Submissions Report

Blind Creek Solar Farm

November 2022

Project Number: 22-319

Figure 4-4 Crop of photomontage 01 (solar infrastructure and proposed vegetation modelling shown in view) (Moir Landscape Architecture , 2022)

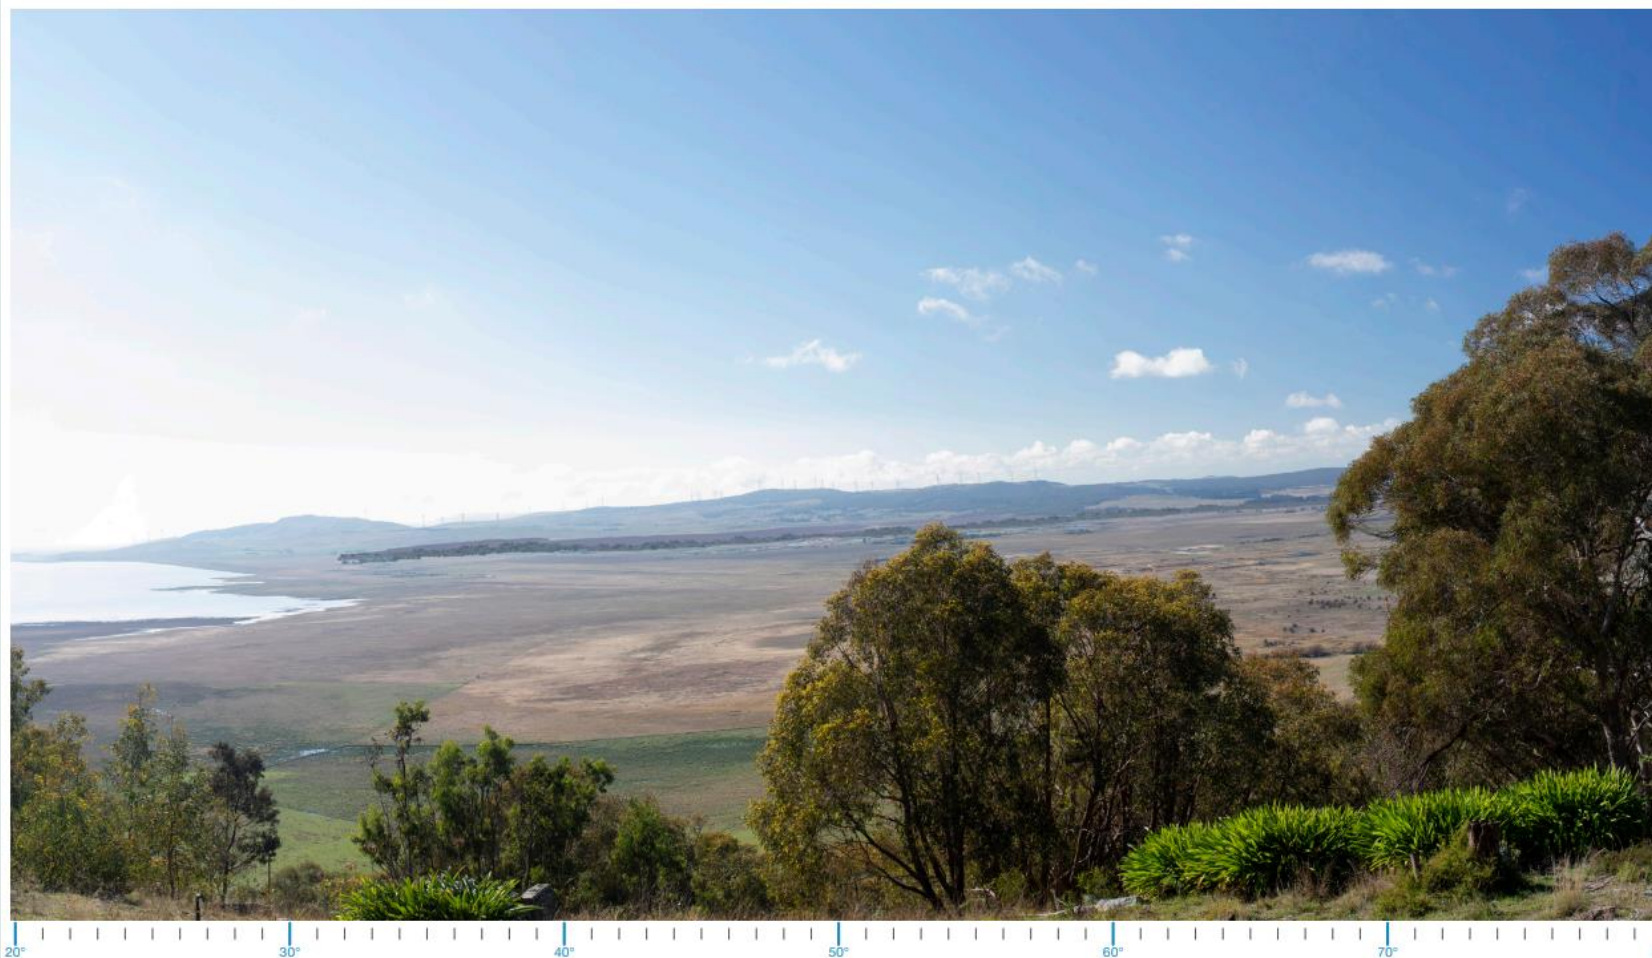
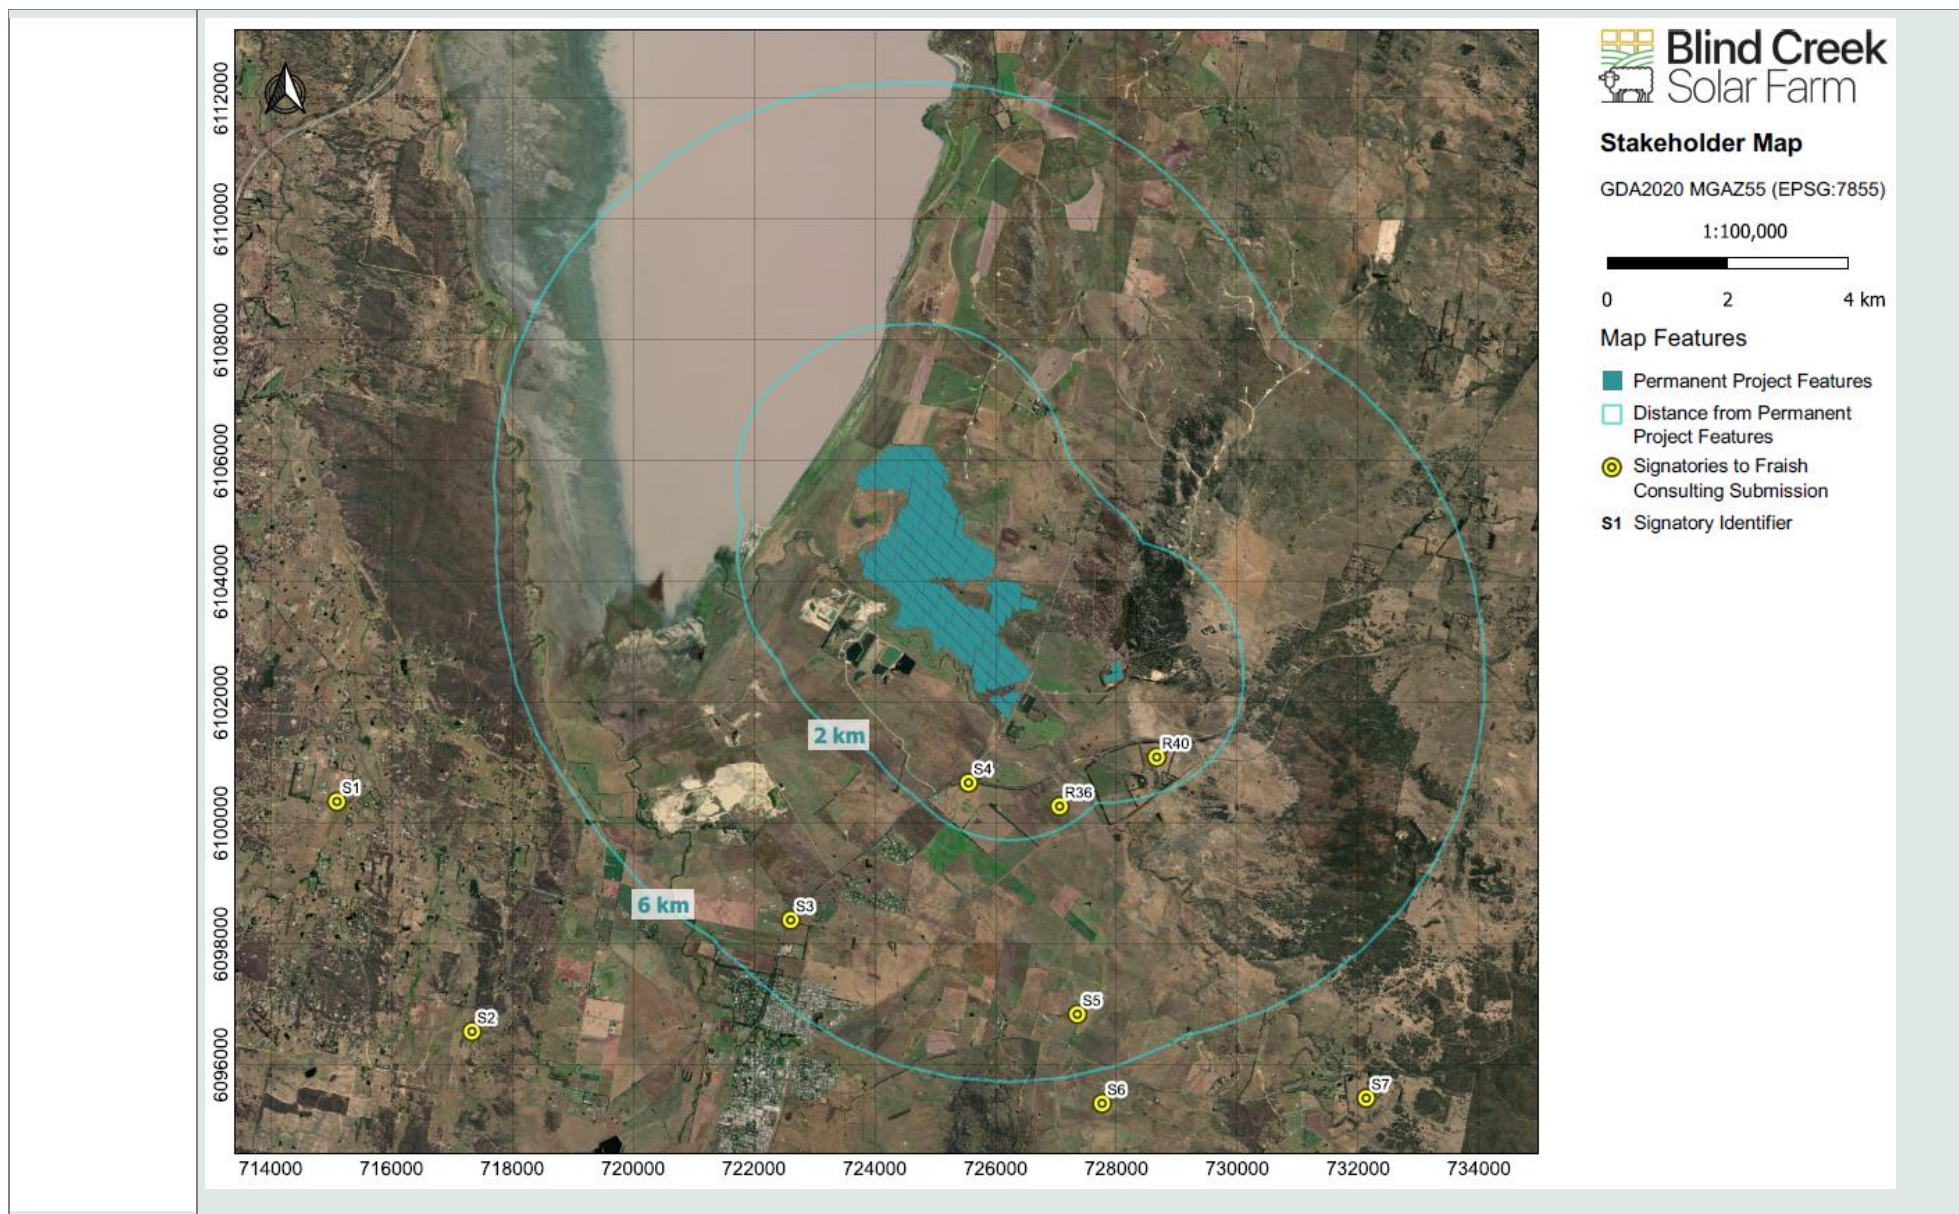
Name	Issue	Detail of issue	Applicant response
	the EIS.	visual impact. • These views be produced with modelling superimposed on photographs. • Consult with surrounding landowners to establish their important locations on their property where there is concern over visual impact. • Identify where the panels obstruct water views of the lake. • Provide detailed simulated data on the angles of the arrays and the resulting daily and seasonal glare that will result from the surrounding properties. The submission makes specific reference to the following receiver and viewpoint locations, which have not had sufficient consideration of visual impact, according to their assessment: • VP04 (800 Tarago Road) • VP05 (Tarago Road) • VP06 (4586 Kings Highway) • VP15 92 (The Forest Road) • VP16 449 (Lake Road) • VP17 68 (The Forest Road) The following receivers are noted as having potential views within 2km of the Development footprint but did not have photographs of their viewpoints provided and further evidence is required to determine their impact; • R37 (886 Tarago Road) • R38 (886 Tarago Road) • R40 (996 Tarago Road) <i>Note: An Example is provided of the viewpoint from VP04 (800 Tarago Road) in the submission (refer to Figure 4-2). This image appears to be elevated about the property and not representative</i>	panel height of 5m, which are the tallest infrastructure components onsite. The ZVI map is shown in Figure 4 of the VIA (Moir Landscape Arcitecture , 2022). The figure provided by the submitter shows an example of views from VP04 (800 Tarago Road), however the photograph seems to be taken from an elevated location that is not representative of the typical view from the residence at VP04. The image also uses a red colour to indicate the location of the solar farm which is not indicative of the colours of vegetation and solar arrays that would be present on site. In addition, panels have been overlaid on areas that are not considered as part of the Project. The figure provided is more in line with that presented in the Scoping Report before the development was refined through the EIS process. The image provided in the VIA for VP04 has been included below as Figure 4-3. This shows a more realistic view from ground level at the property in question. It should be noted that 3D modelling is included in the image however it is not easily viewed from VP04 and views of the Development site are fleeting from ground level (Moir Landscape Arcitecture , 2022). A clearer view of the 3D modelling in the VIA is provided for VP14 which has been provided below as Figure 4-4 for reference. The assessment of receivers R37, R38 and R40 did not include photographs due to the properties lack of elevated views and significant vegetation screening. This is shown in the VIA in Figure 7 (Moir Landscape Arcitecture , 2022). A summary of the details for each signatory is detailed in the table below. Refer to Figure 4-5, showing the location of signatories in the Fraish submission

Name	Issue	Detail of issue	Applicant response
		of the views from the dwelling at 800 Tarago Road which was provided at ground level in the Landscape and Visual Assessment (Moir Landscape Architecture , 2022).	
 Figure 4-2 View from VP 04, 800 Tarago Road of Project area as provided by Fraish Consulting

Name	Issue	Detail of issue		Applicant response
	800 Tarago Road, Bungendore	R36 (VP04, Photo montage 3 in the VIA)	1.7km from solar array, 2.2km from BESS and substation	Property assessed as 'Negligible' in the VIA. Considered in Reflective Glare study but excluded from the 'project assessment receivers' due to views blocked by existing vegetation and topography. Included in Community Benefit Sharing Scheme and fully consulted with prior to EIS lodgement
	61 Warramunga Close, Wamboin	S1	10 km from solar array	Not considered in VIA or Reflective Glare Study due to distance and no view.
	3775 Kings Highway, Bungendore	S7	8.7 km from solar array	Not considered in VIA or Reflective Glare Study due to distance and no view.
	656 Tarago Road, Bungendore	S4 (VP05 in the VIA)	No residence	Property assessed as 'Negligible' in the VIA. Stakeholder requested VP05 photo to be taken from highest point on land as no residence on property. Also provided with a photomontage depicting negligible view of solar array. Included in Community Benefit Sharing Scheme and fully consulted with prior to EIS lodgement.

Figure 4-6 Crown land easement map provided in Crown Lands response

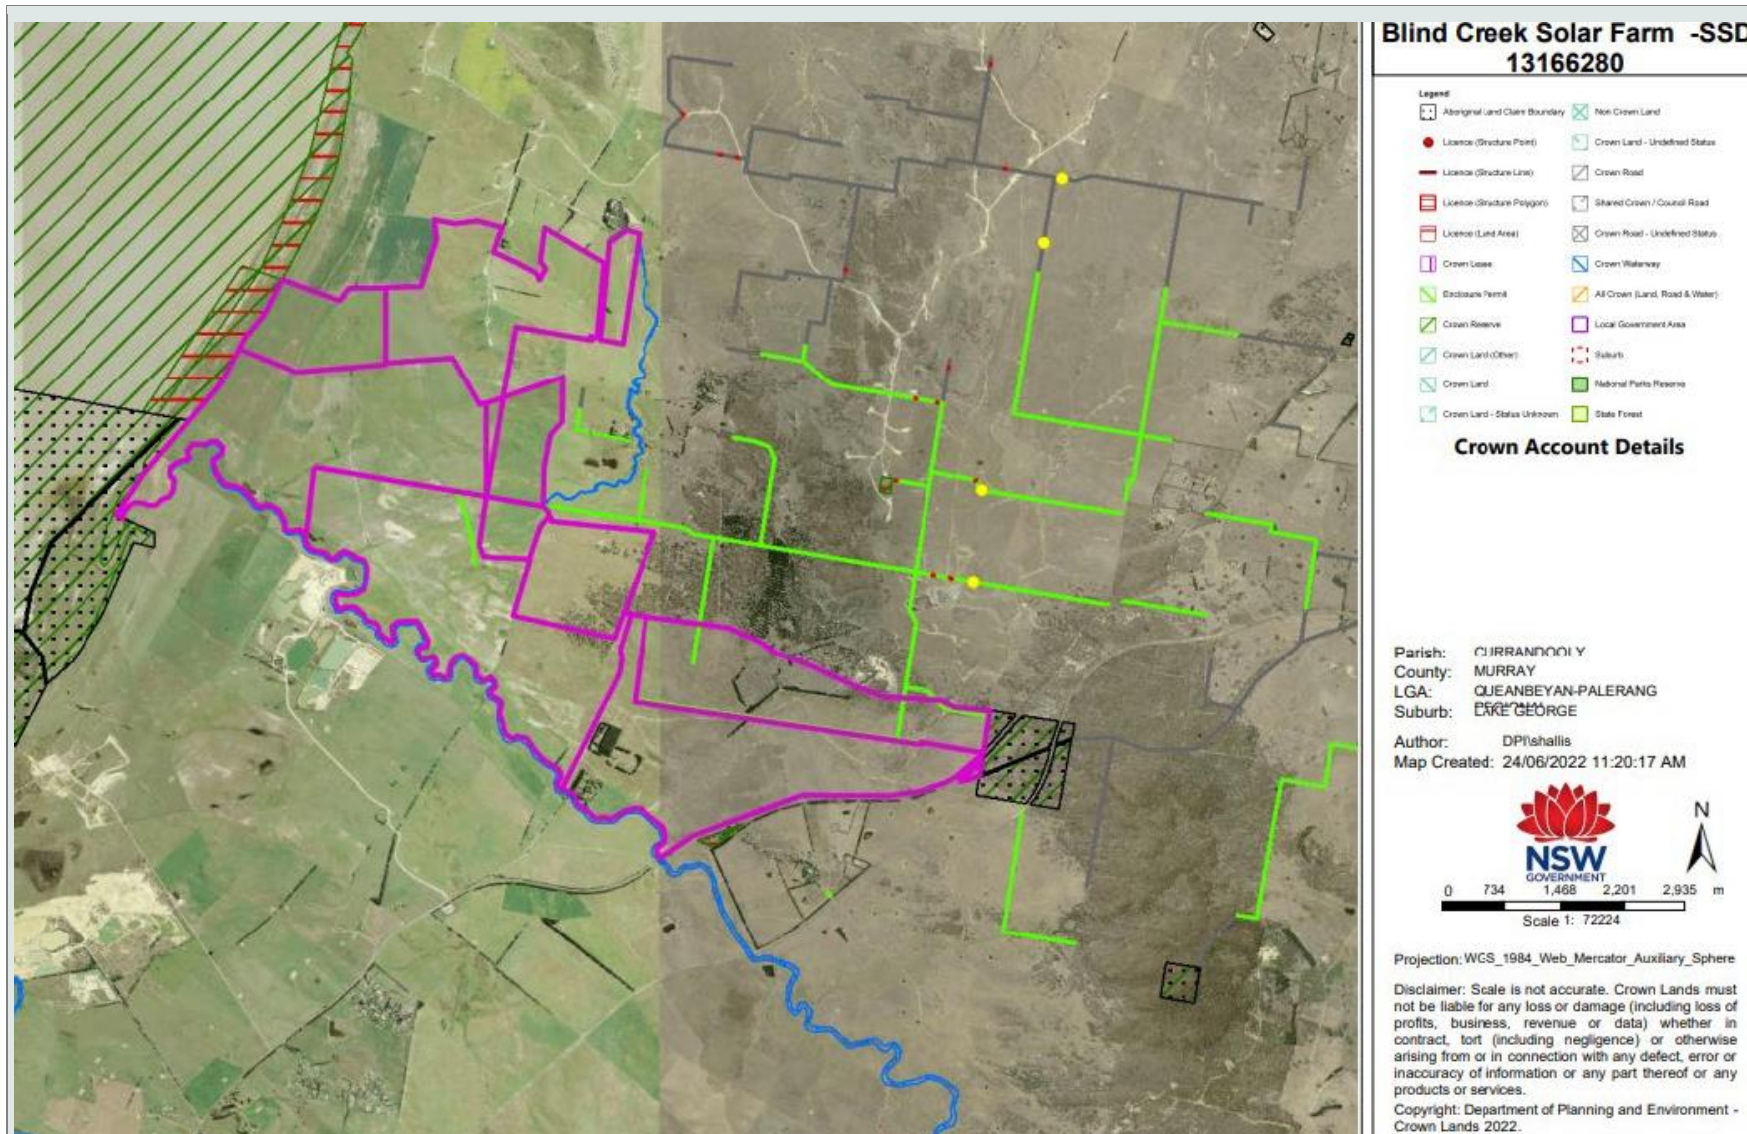
Crown roads	Lineal Infrastructure (e.g. Pipelines and/or Electricity Transmission lines) traversing Crown land/roads If lineal infrastructure (such as pipelines and/or electricity transmission lines) are expected to traverse Crown roads and/or waterways, an easement over said Crown land, roads and/or waterways will be required for protection of the infrastructure. To discuss easement requirements, please contact the Acquisitions team at the earliest	This response is covered in the responses above. Easement for running cables through Crown Land within Lot 1 DP 456698 would be applied for when final designs are approved following development consent. The need for this easement was noted in Section 9.2.3 of the EIS (NGH , 2022)

Issue	Detail of issue	Applicant response
	opportunity at: cl.acquisitions@crownland.nsw.gov.au. In order for transmission lines to traverse Crown land and/or roads, the Applicant will need to apply for easements. Information regarding the easement process is available at the below link: https://www.industry.nsw.gov.au/lands/use/easements As the easement process may be lengthy, it is also recommended that the Applicant apply for a licence for each Crown road and Crown land lot as soon as possible. A licence will temporarily authorise use and access for the infrastructure to traverse Crown roads and Crown land whilst the easement applications are being processed. Details on how to apply for a licence are available at the below link: https://www.industry.nsw.gov.au/lands/use/licences The Department may also need to consider the transfer of the affected Crown roads to the local Council. It is important to note that licences or easements must be in place before infrastructure can traverse Crown land or roads. It is important to note that authority must be in place before Crown land or roads can be used, traversed, accessed or infrastructure can be built.

Figure 4-7 Schematic of a mounted PV module. Dimensions shown are indicative only and are for the larger 2P configuration; extract EIS Section 4.

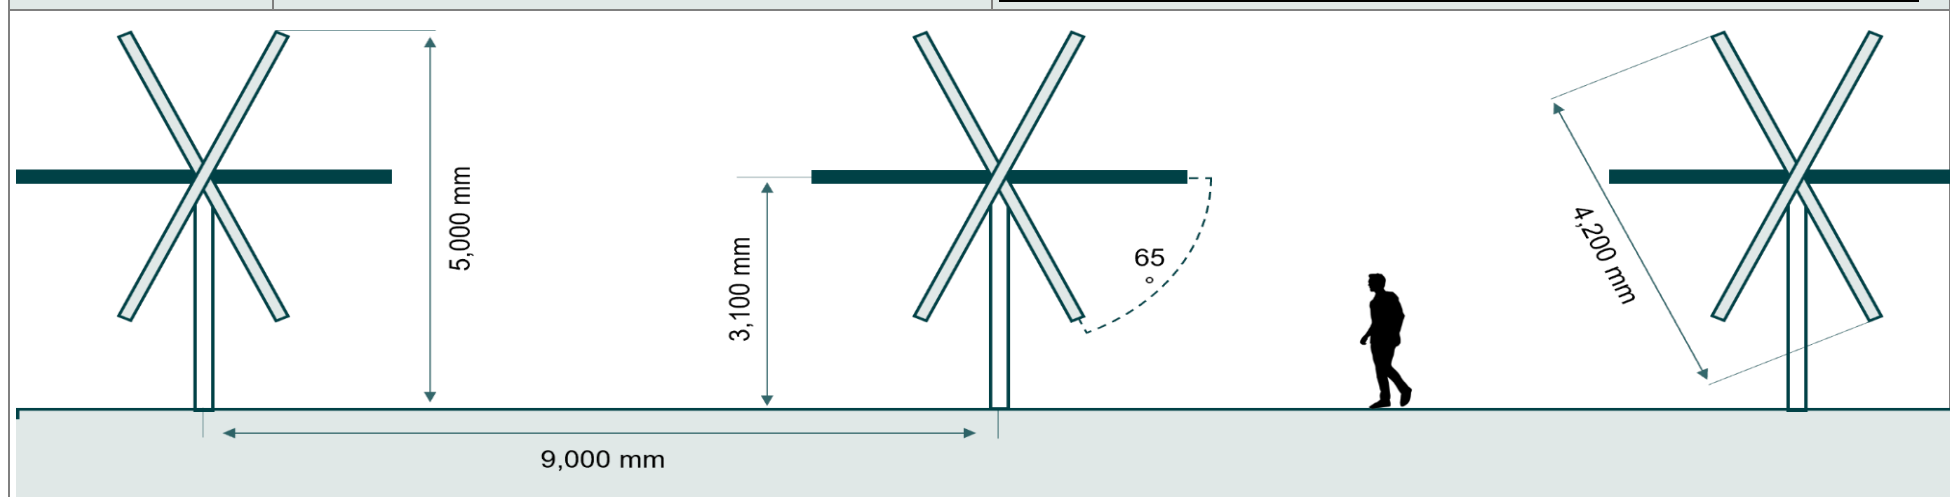
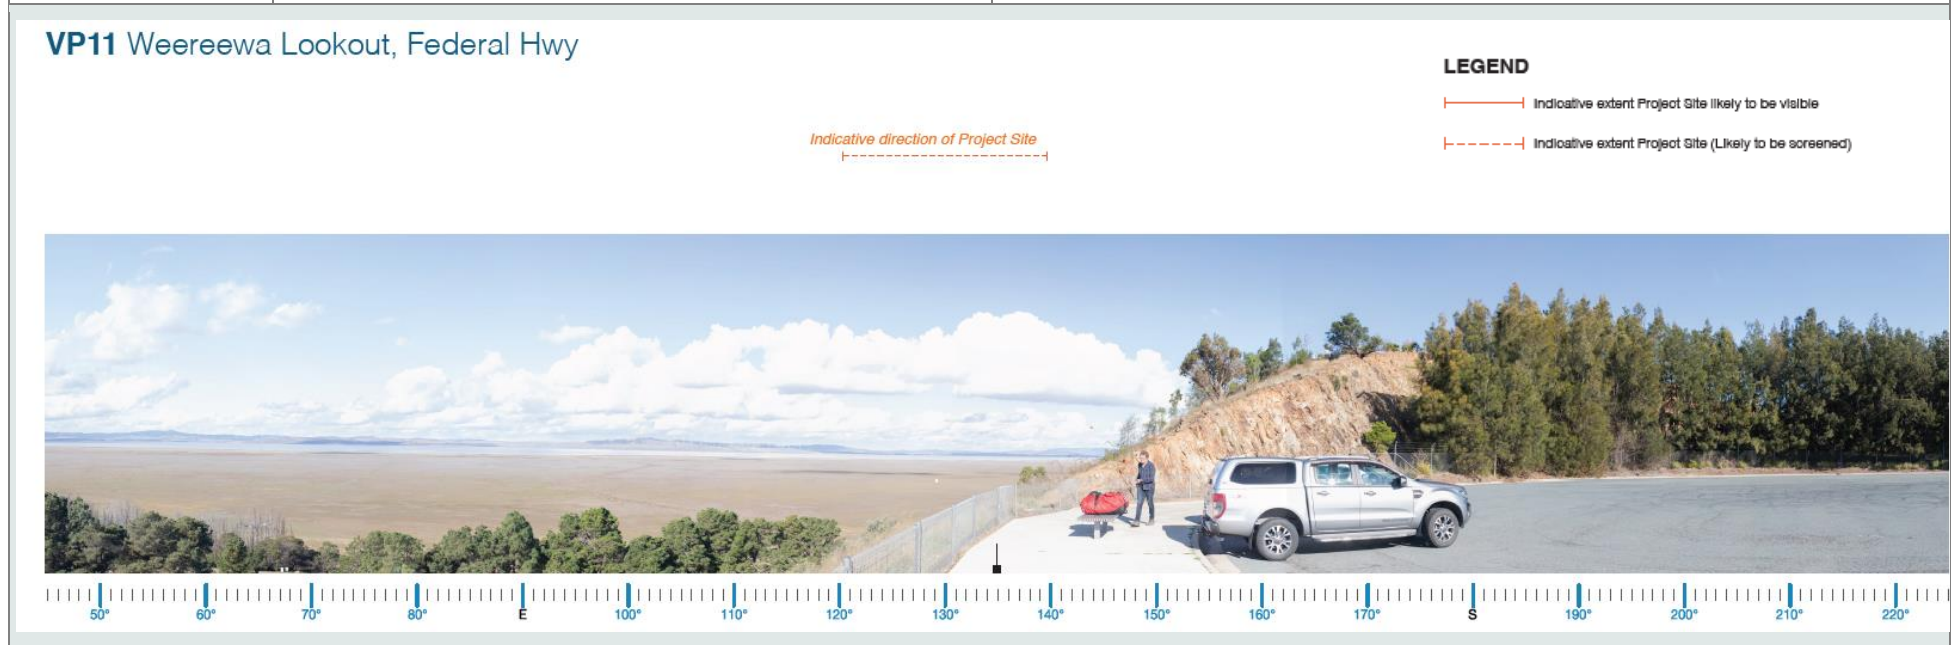
Issue	Detail of issue	Applicant response										
	embedded at least 150mm into the base of the waterway.											
Department of Primary Industries (DPI) Agriculture												
Agricultural use	There is a commitment in the EIS for the site to be used for continuing agricultural purposes (sheep grazing) as part of its management (p13). In particular integrating sheep grazing with solar production and incorporating regenerative agriculture practices, a soil carbon project, biodiversity restoration and compost production is proposed and fully supported by NSW DPI.	The Landowner has entered into a formal agreement with the Applicant to carry out grazing of sheep and inter row forage cropping within the solar array area. The Landowner currently practices regenerative agriculture and has commenced the process of registering a soil carbon project with the Australian Government's Clean Energy Regulator. It is the intention of the Landowner that the soil carbon project will include the solar array area following construction of the solar farm. The Landowner has recently carried out biodiversity restoration projects with Greening Australia and Local Land Services on land adjacent to the Development site. The Landowner is also a participant in the Australian Holistic Management Co-operative's 'Ecological Outcome Verification' program and the NSW Government's 'Land For Wildlife' program. The Landowner has also received development approval to construct a green waste compost facility on land adjacent to the Development site. Humus compost from the facility will be used to rehabilitate and fertilise soil throughout the solar array area and adjacent farm land controlled by the Landowner.										
	There is however no commitment in the EIS as to the height of the panels to enable the sheep to graze underneath them. The article quoted in the EIS (table 9-6, p258) by the Clean Energy Council (Australian Guide to Agrisolar for Large-scale Solar: For Applicants and farmers) states that the height of panels to enable sheep to graze beneath them should be between 2.5m and 5m. A commitment to the panel height should be made to ensure the project outcomes can be achieved.	There is still a level of uncertainty around the final choice of technology, design and panel height. A final commitment cannot be made in the RTS, but will be made in the final design and presented to DPE. Below details a worst case scenario for panel height for a 1P and a 2P arrangement, allowing for flood mitigation: <table><tr><td></td><td colspan="2">1P</td><td colspan="2">2P</td></tr><tr><td></td><td>No flood</td><td>Max flood</td><td>No flood</td><td>Max flood</td></tr></table>		1P		2P			No flood	Max flood	No flood	Max flood
	1P		2P									
	No flood	Max flood	No flood	Max flood

Issue	Detail of issue	Applicant response			
		Height of top of panel when at maximum tilt	2381	2881	4262
		Height of bottom of panel when at maximum tilt	500	1000	1000
		Height of panel when horizontal	1441	1941	2381
		Average hours per day when bottom height of panel is less than 1m height	19	0	5.8
